RBG-46583

SUBJECT: License Amendment Request
Changes to the Analytical Methods Referenced in Technical Specification
5.6.5, "Core Operating Limits Report (COLR)"
River Bend Station, Unit 1
Docket No. 50-458
License No. NPF-47

Analysis of Proposed Technical Specification Change

**Proposed Technical Specification Changes (mark-up
includes affected Operating License page)**

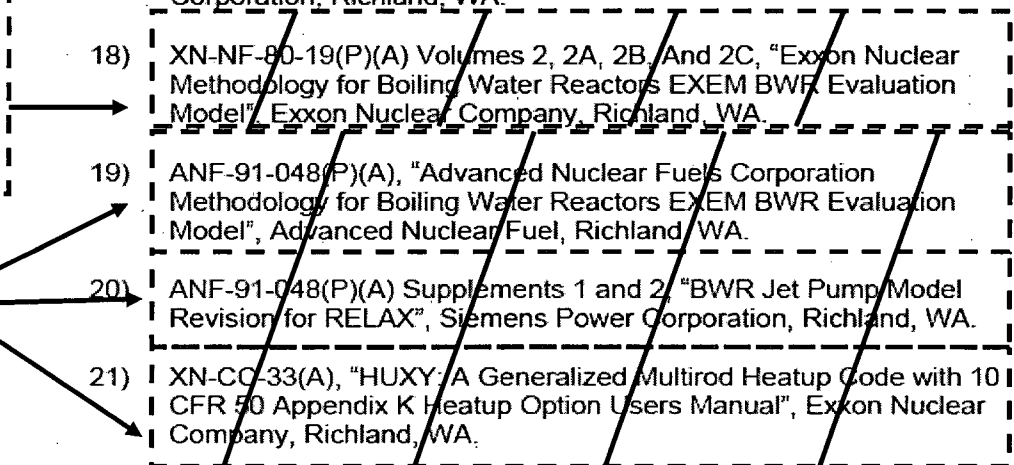
- 18) XN-NF-80-19(P)(A) Volumes 2, 2A, 2B, And 2C, "Exxon Nuclear Methodology for Boiling Water Reactors EXEM BWR Evaluation Model", Exxon Nuclear Company, Richland, WA.

- 19) ANF-91-048(P)(A), "Advanced Nuclear Fuels Corporation Methodology for Boiling Water Reactors EXEM BWR Evaluation Model", Advanced Nuclear Fuel, Richland, WA.

- 20) ANF-91-048(P)(A) Supplements 1 and 2, "BWR Jet Pump Model Revision for RELAX", Siemens Power Corporation, Richland, WA.
- 21) XN-CC-33(A), "HUXY: A Generalized Multirod Heatup Code with 10 CFR 50 Appendix K Heatup Option Users Manual", Exxon Nuclear Company, Richland, WA.

EMF-2361(P)(A),
 "EXEM BWR-2000
 ECCS Evaluation
 Model," Framatome
 ANP Richland, Inc.

Deleted
